## **ALERT SERVICE BULLETIN**

**407-21-124**

**SUBJECT:** FUEL SYSTEM STANDPIPE ASSEMBLY 407-062-032-103, ONE-TIME INSPECTION AND REWORK OF.

**HELICOPTERS AFFECTED:** Serial numbers 54832 through 54931, 54933 through 54939, and 54942 through 54954.

**Figure 1 – Examples of Non-Conforming Internal Welds Joints**

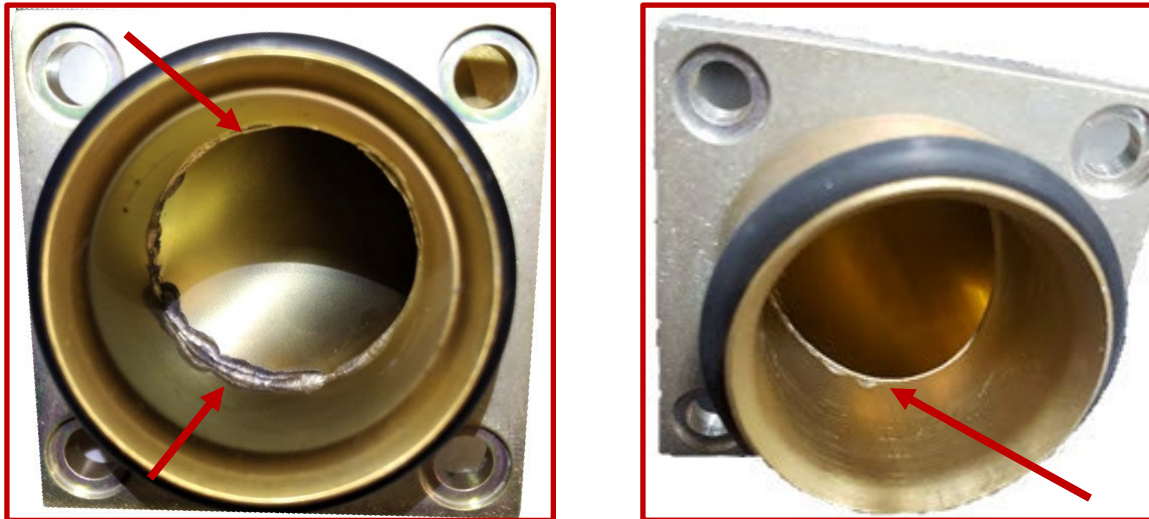
Bell has been made aware of a quality escape from our current supplier of the fuel system standpipe assembly 407-062-032-103. Some standpipes may have been delivered with sharp edges at the internal weld joints (Figure 1). If not corrected, this could lead to fuel quantity system wiring damage and loss of, or erratic, fuel quantity indication.

3. Inspect interior of fuel system standpipe for evidence of sharp edges of the two internal weld joints (Figure 1).
  - a. If no sharp edges are present, go to step 4.

- b. If sharp edges are present, lightly deburr edges of weld joints using aluminum oxide abrasive cloth or paper (commercial) (Figure 2). Make sure not to exceed 0.015 inch (0.38 mm) depth into the tube material at a 45 degree angle to the weld joints.
